SHOP DRAWING REVIEW

Job Number: 57632.00
 Reviewed By: E.F. LAWES
 Date: June 8, 2015

6			
5			
4			
3			
2			
1	4/29/15		FOR APPROVAL
	DATE	REV.#	SENT FOR
	DIMENSION		
	DIMENSION FABRICATORS INC.		
	2000 37th STREET SCOTIA, N.Y. 12302 Ph: (518) 374-1838 Fax: (518) 374-4833 www.dimensionfabricators.com		
STRUCTURE	CASTLETON BRP 015-2(10) CLOSURE POURS REINFORCING		
LOCATION	CASTLETON, VT		
ARCHITECT			
ENGINEER			
CUSTOMER	W.M. SCHULTZ CONSTRUCTION INC.		
DRAWN BY	DATE	DATE	DR #
Ed Eras	4/29/15		9248
DRAWING COVERS			DRAWING #
APPROACH SLABS CLOSURE POURS DUAL COATED REINFORCING			B

BRIDGE CLOSURE POURS PLAN

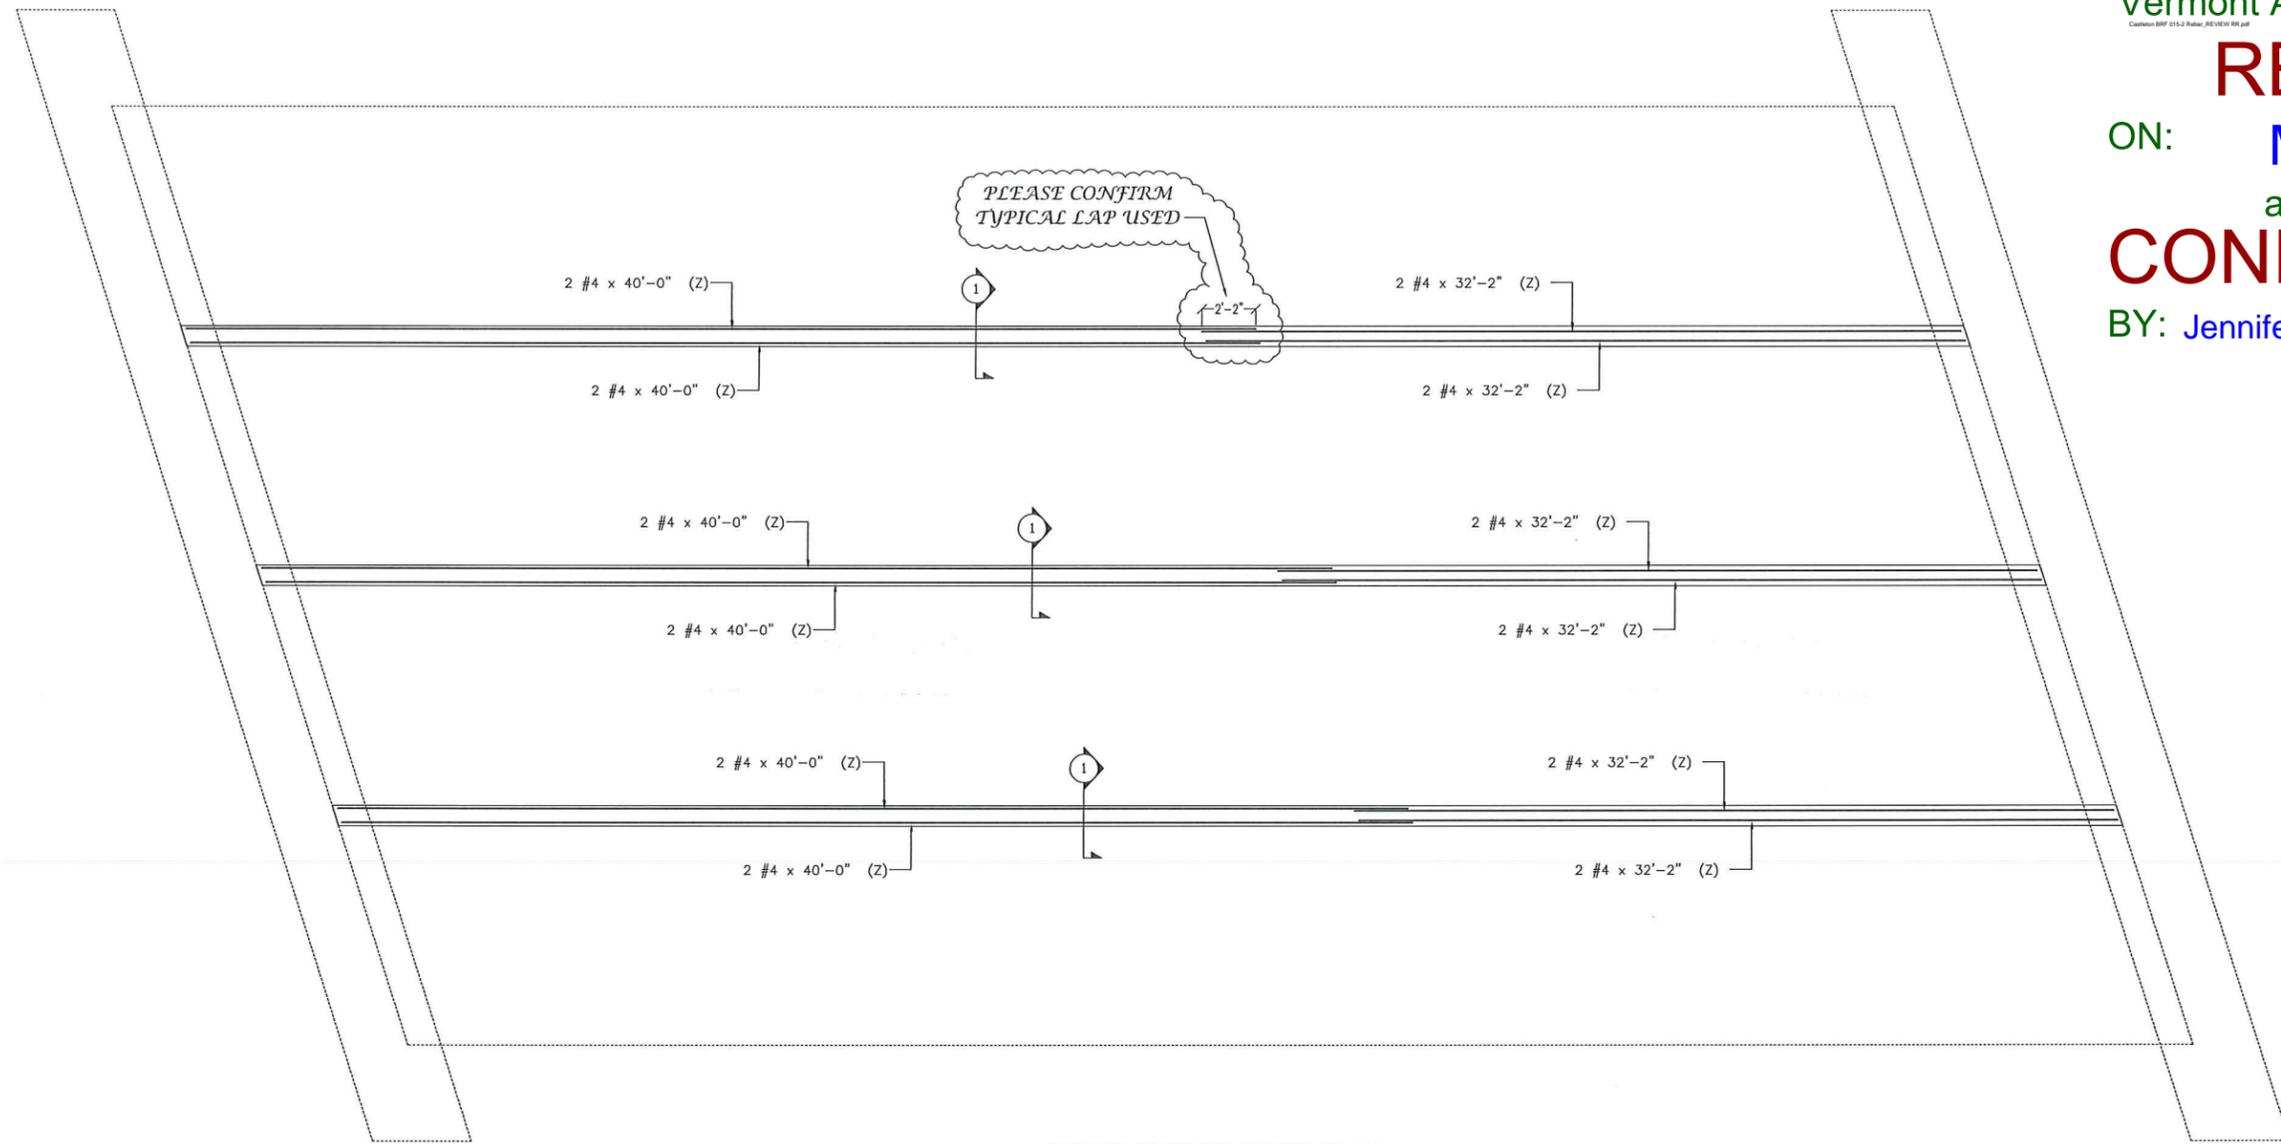
DETAIL DOES NOT MATCH CLOSURE POUR JOINT SHAPE AS SHOWN IN THE SHOP DRAWINGS.

BRIDGE END #2 ELEVATION

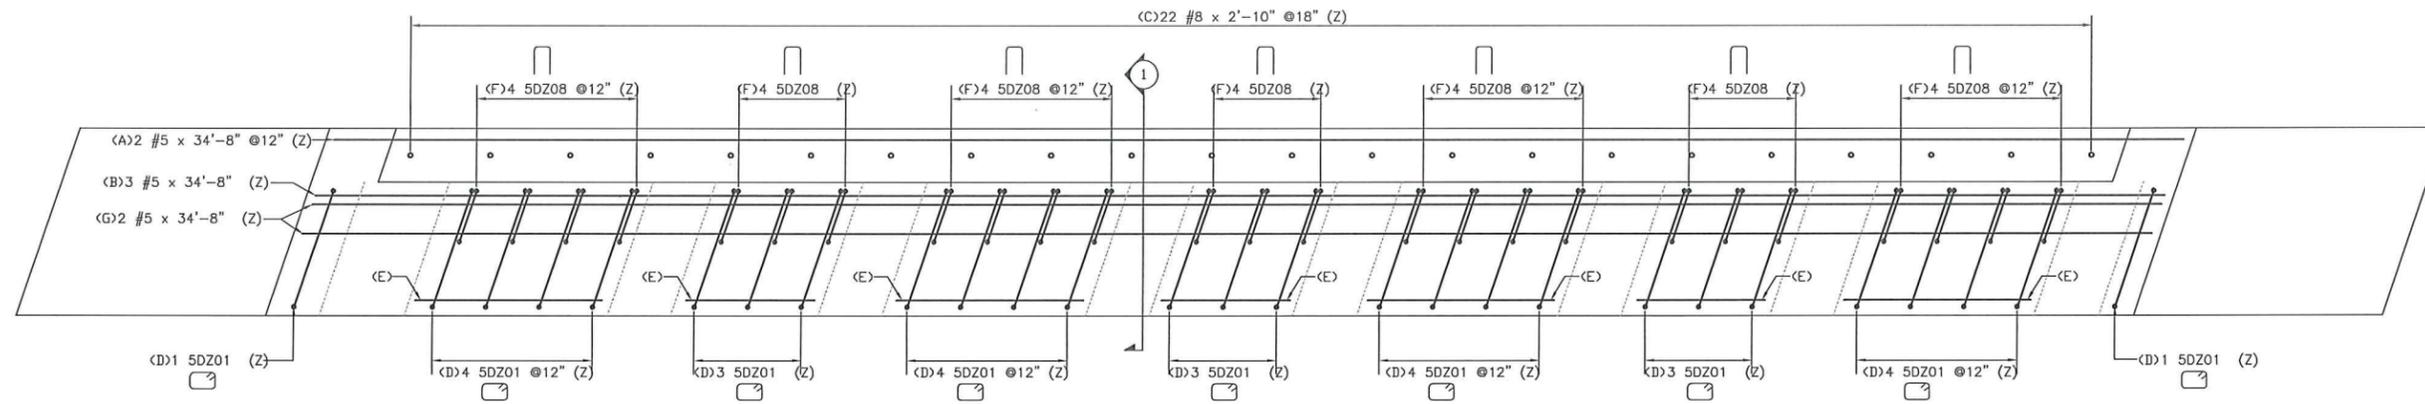
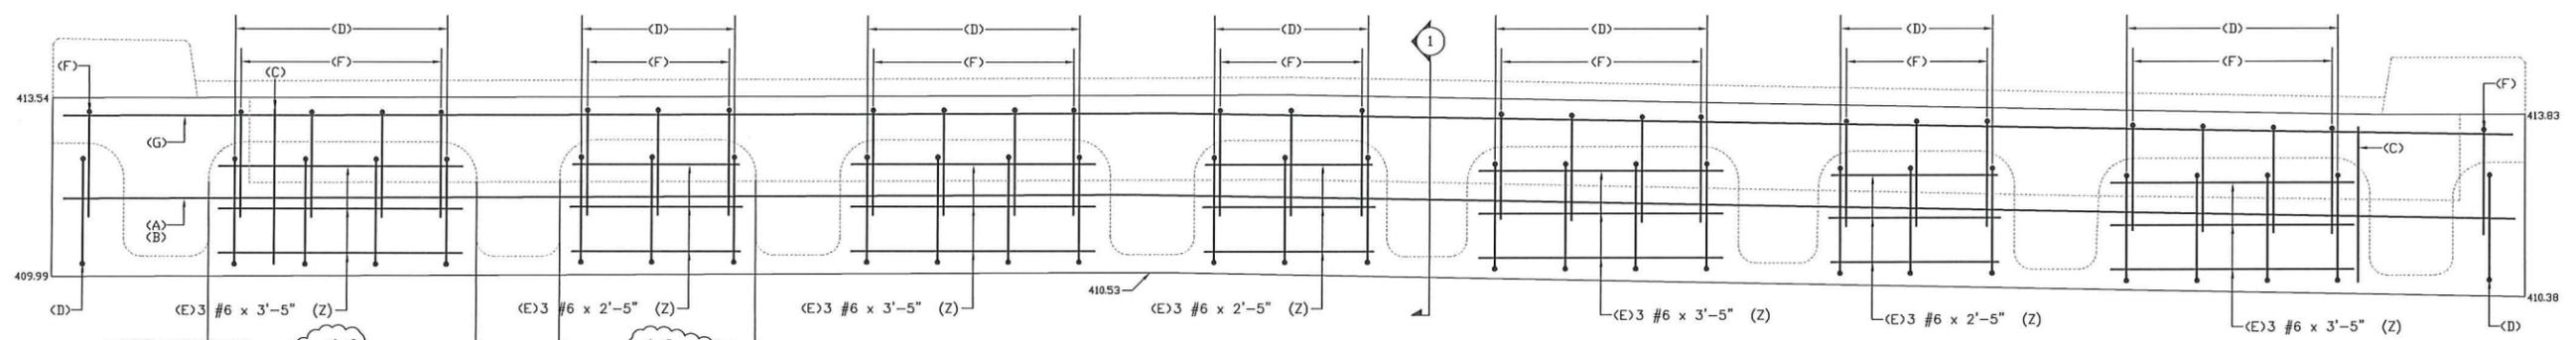
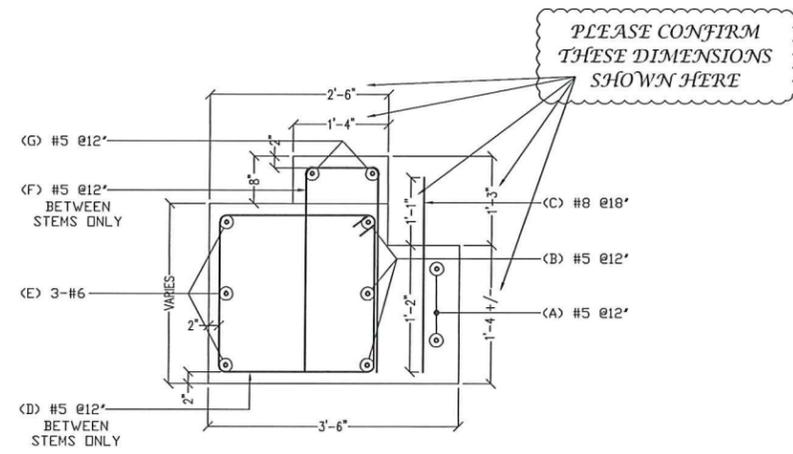
PLEASE CONFIRM THIS DIMENSION

PLEASE CONFIRM THIS DIMENSION

SEE COMMENTS ON PREVIOUS SHEET AND REVISE.

PLEASE CONFIRM THESE DIMENSIONS SHOWN HERE
